PLANNING COMMISSION

AGENDA ITEM: 3. Site Plan Review – Automotive Enterprises, Inc.

On June 13th, a revised final site plan, meeting minimum standards of Code Section 44.06 (b) (site plan ordinance) was submitted for the auto dealership. The full submittal package is attached. In accordance with Council request, the Planning Commission was scheduled to consider the plan on June 23rd. Notice of this schedule, along with copies of the submitted plan (11 X 17 format) were forwarded to all property owners who had received notice of the zone change. Copies of the plan were also forwarded to staff of the City site plan review team with the invitation to conduct an "in-house" review of the plan on June 17th. Given this review, the following comments/corrections were presented:

REVISION DATE	REMARKS
FIELDBOOK: XXX	
SCALE: AS SHOWN	
DRAWN: SFS	
CHECKED: DRC	
DATE: 06/09/2014	
UTILITY, GRADING AND DRAINAGE PLAN DAHL GM WINONA, MINNESOTA	
DAVY ENGINEERING CO. LA CROSSE, WISCONSIN

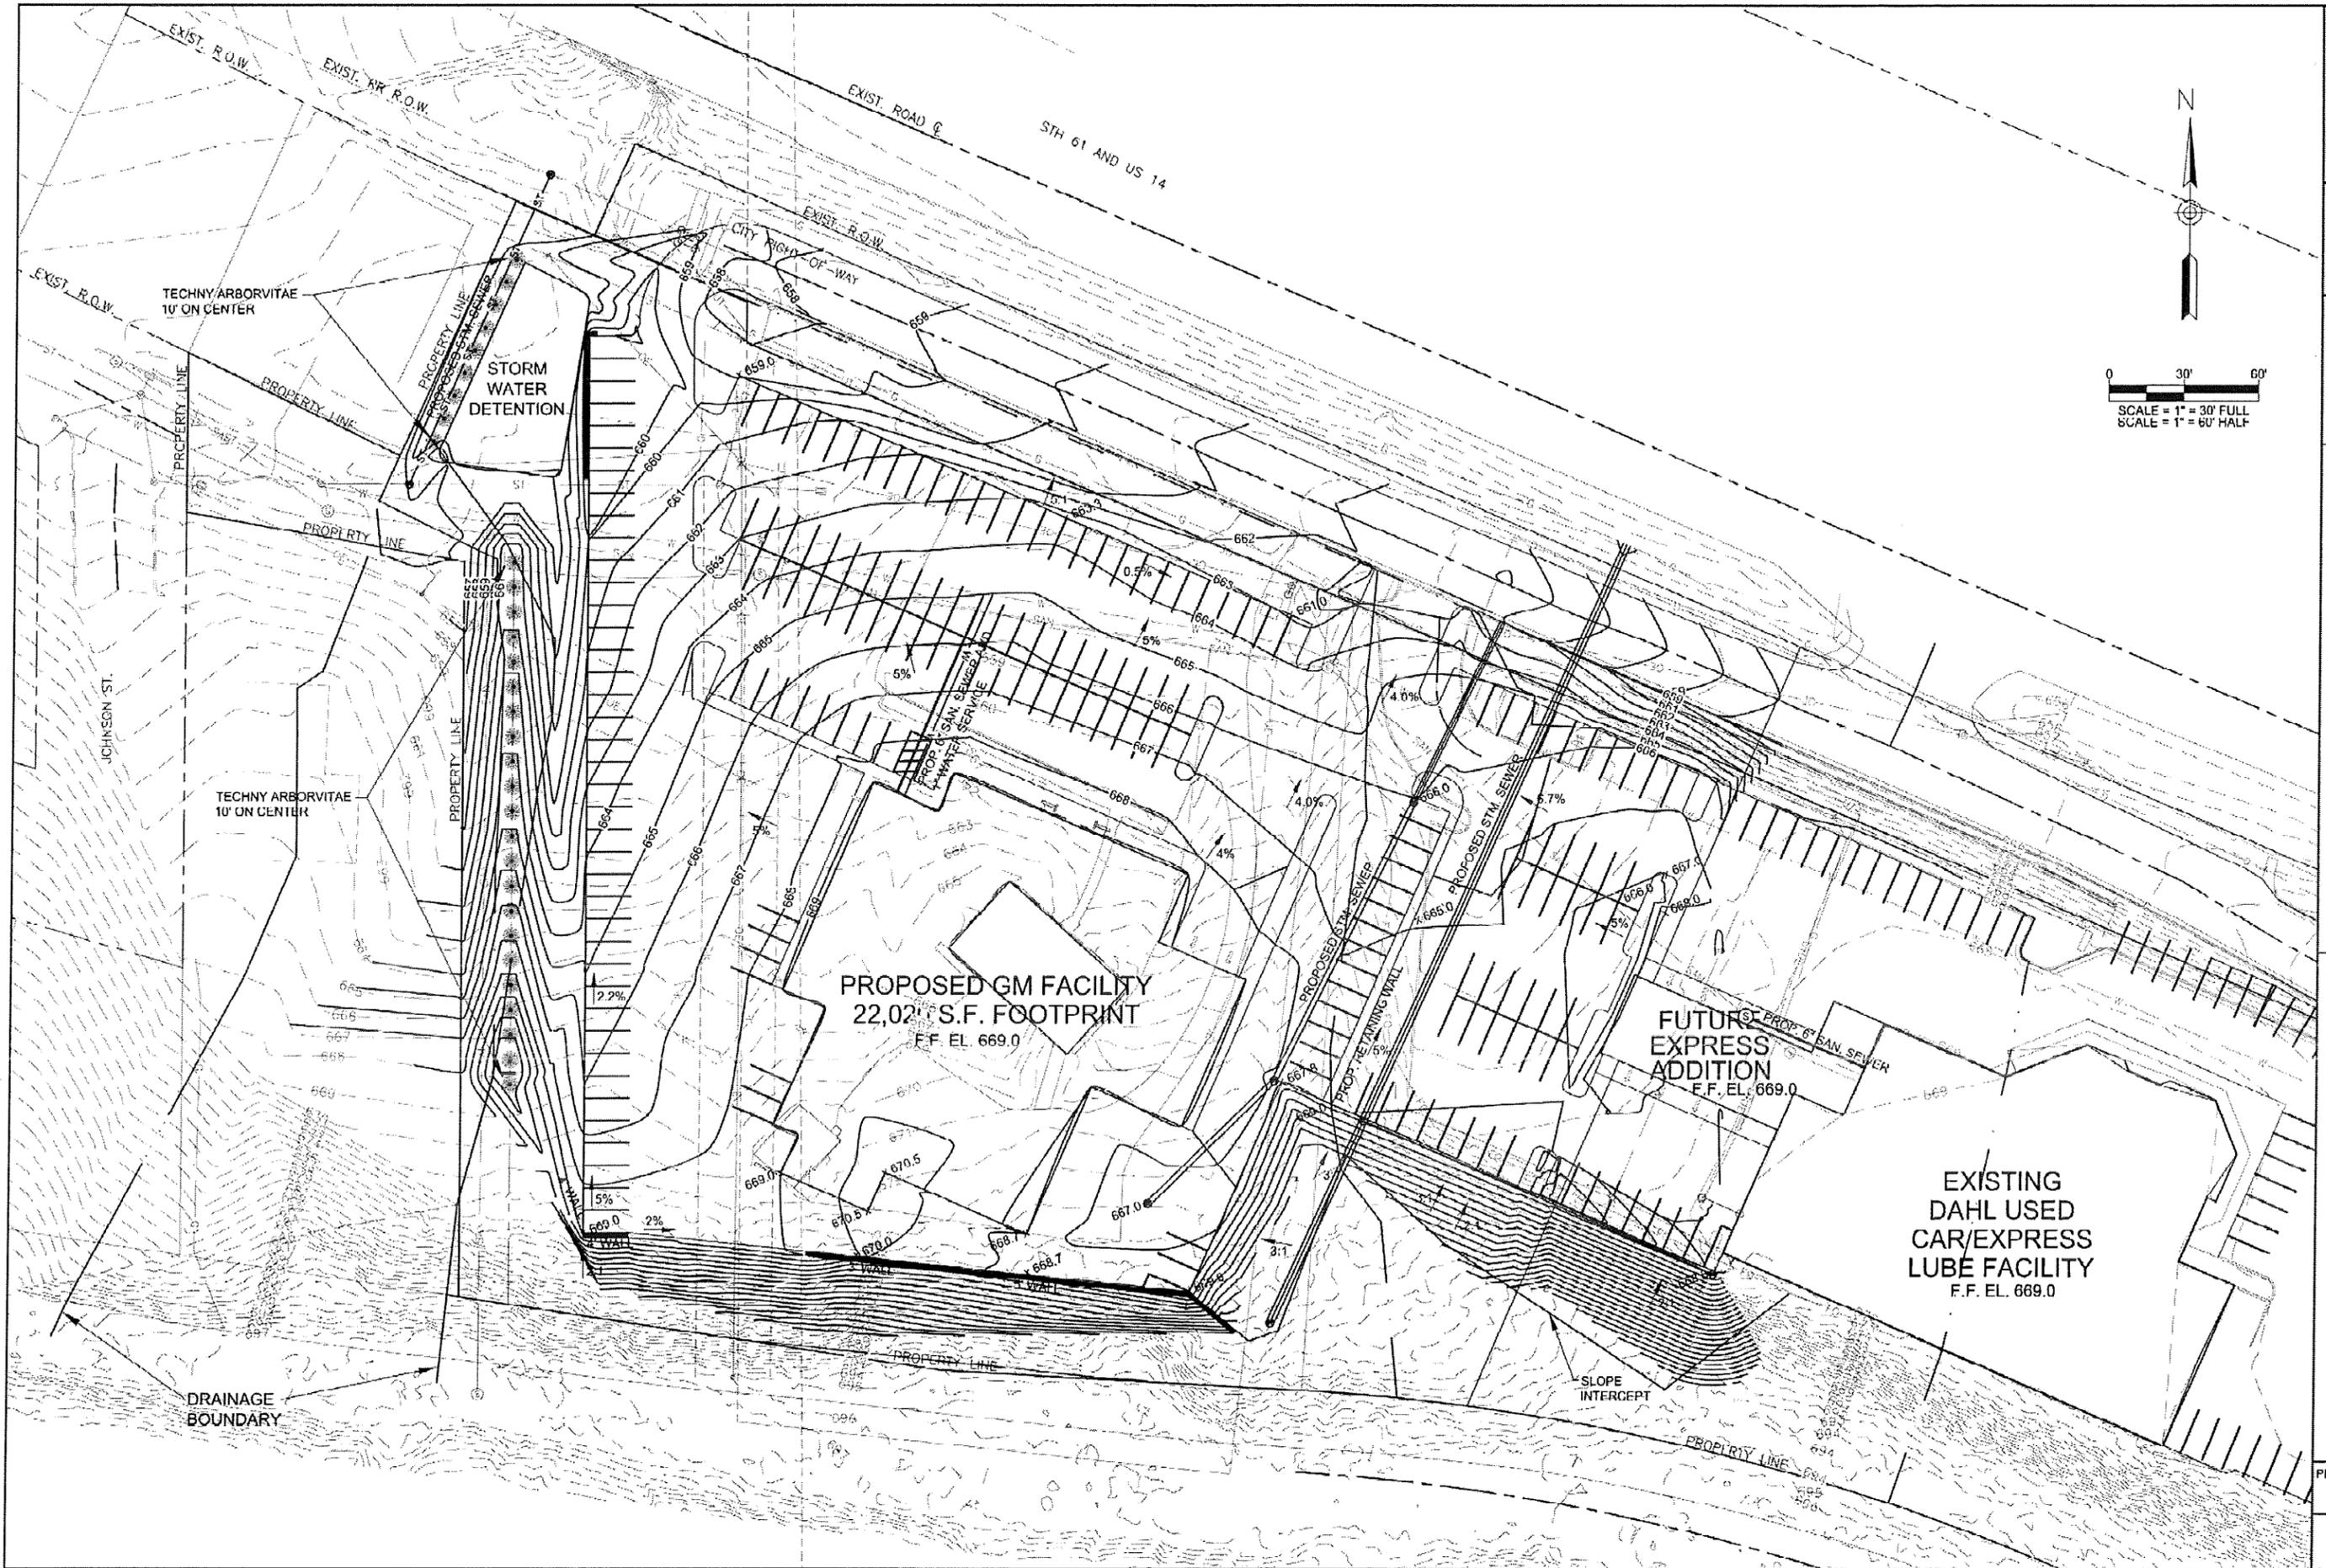
- A general comment from all department representatives was that a more legible plan, reflecting all existing and proposed City utilities, needs to be presented. Although utility locations are shown on the utility/drainage plan, line quality of this plan is such that, with topo and other defined features, information is confusing, sizes of current utilities are not shown, and current hydrant locations were hard to find.

- Engineering. A completed stormwater management plan will need to be permitted by the City Engineer prior to any form of site grading. Project will also require an NPDES permit, and may require permits from MNDOT and others. Given that required stormwater management features (i.e.: retention ponds) may affect site plan design, both need to be developed hand in hand. Is the pond, represented on the site plan, of adequate size to serve the development? Storm sewer construction will need to consider relatively shallow existing sanitary mains. In order to minimize the amount of landscape berm fill located over the sanitary sewer line easement (west side), the City Engineer recommends moving the berm as far to the "east" as possible. Unclear of the purpose of 2 north/south storm sewer lines running to Service Drive (east side of development)?

- **Storm Drainage.** As currently proposed, the majority of storm drainage from the site will be directed to the Highway 61 ditch (north of stormwater detention pond) where it flows under the highway to its north side, then easterly. In part, the present plan shows that the drainage from the westerly third of the site will be directed to the stormwater holding pond while the remainder of the site will be served by storm sewers and sheet flow to existing ditches. Although the site plan package does include a concept for site drainage, details of this element are still developing. In response to neighborhood contacts, staff has heard concerns of the design and maintenance of the detention pond. Will the pond hold water continuously, will mosquitoes be controlled, and will it be mowed? These questions will need to be addressed prior to plan approval.

1 SITE PLAN
A-0.1 1" = 30'-0"

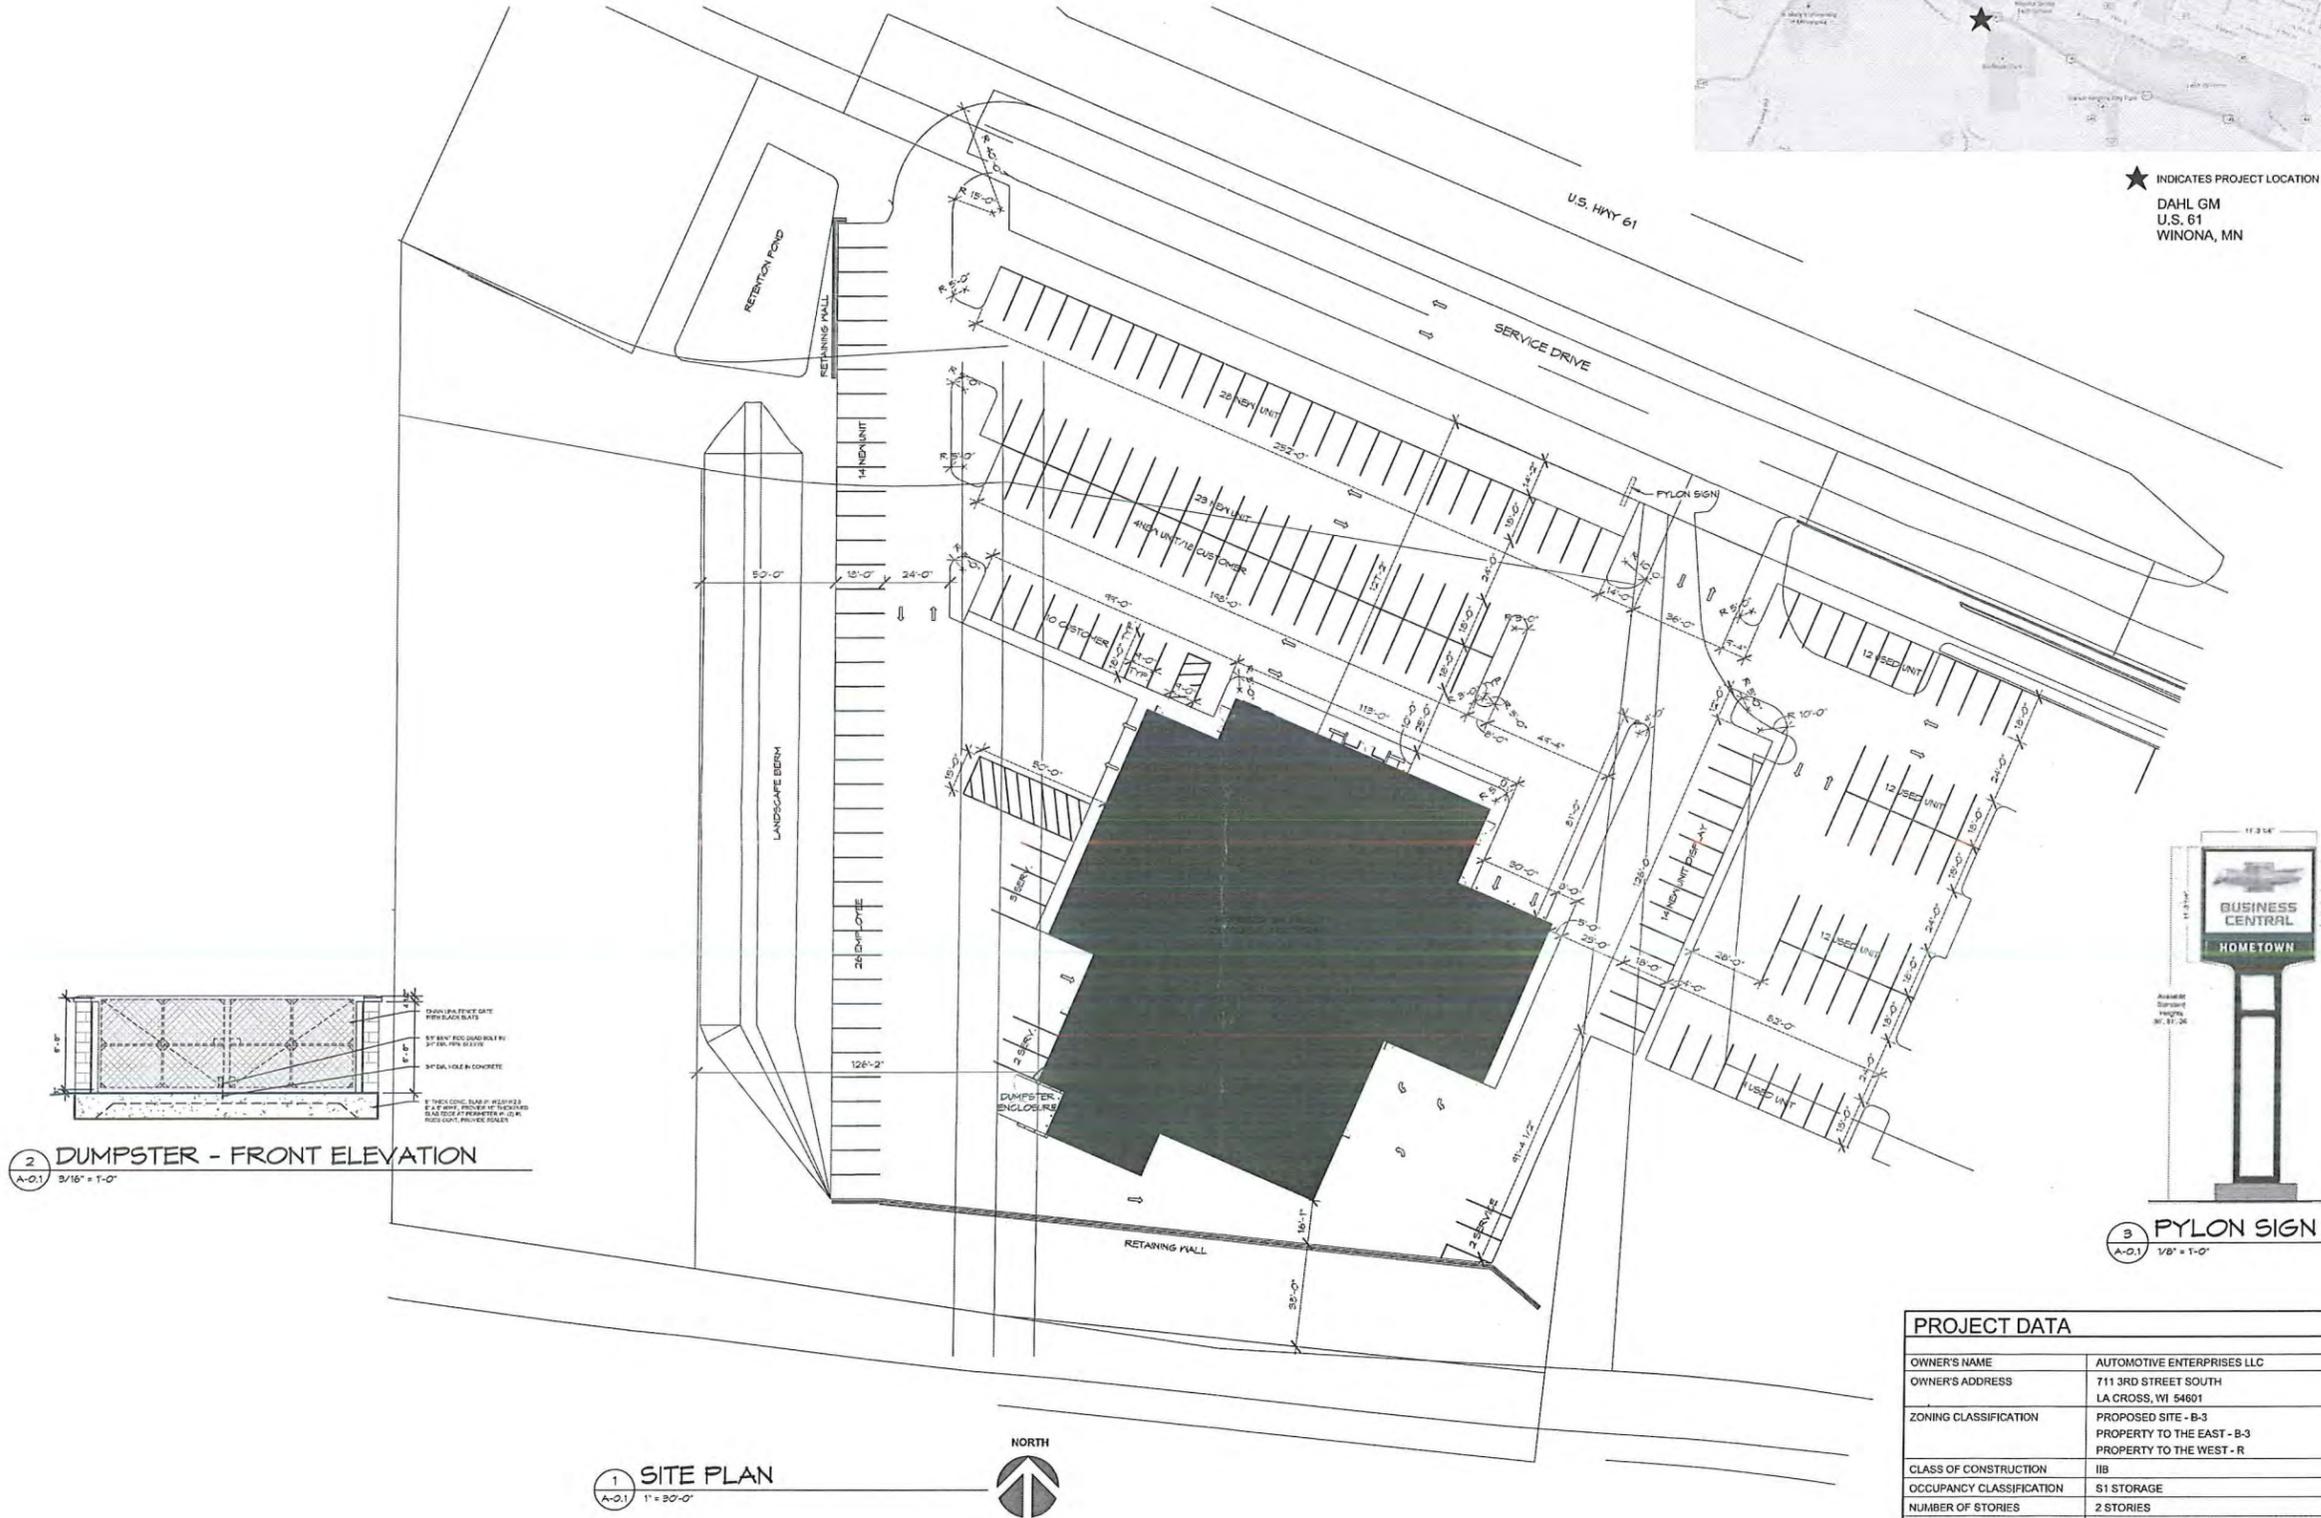
- Fire Department. Although not reflected on plans, the project will, given the planned unsprinkled building, require a minimum of 2 additional hydrants at the site. Although specific locations for these are being explored by the Fire Marshall, tentative new locations will include the south/east sides of the site. Current hydrants will need to be relocated to protected areas. In addition to these, a minimum distance of 20 feet will be required between the retaining wall and the south side of the building for fire access (16 feet is shown). Are the radii of the curve at the proposed northwest parking lot entrance adequate for convenient City fire truck access? This should be certified with the Fire Marshall.

- Other. Pylon sign needs to be fully located on private property. What is the depth of the detention pond, and will it contain water throughout the year? Berm landscaping will need to be maintained/replaced to ensure consistent screening (may need an agreement for this).

- **Site Access.** Given concerns of neighboring residents, approval of the zone change was subject to certain conditions that were designed to restrict vehicular access to/from Lake Boulevard (south) and the Johnstones Addition (west) and the development site. The site plan shows that primary access will be from Service Drive. No alternative access points to the west and south are proposed.
